Narrative Responses to Staff Comments

1840 Alton Road

PB22-0480

Date: February 28, 2022

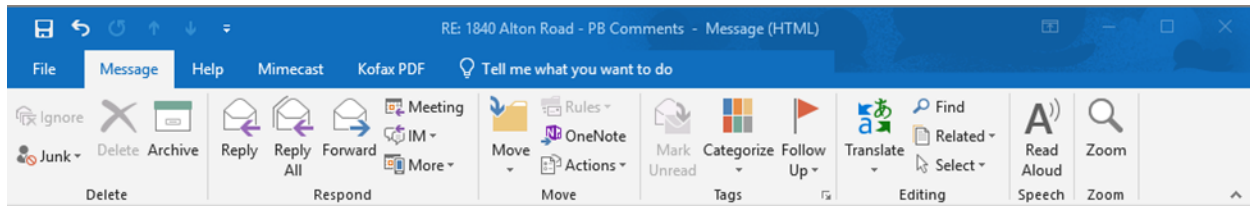
We are proposing a Code Amendment in conjunction with our PB application. Specifically, we are proposing to expand the Alton Road Office Development Overlay along the west side of Alton Road between Dade Boulevard and 20th Street minus three lots at the corner of Alton and 20th street.
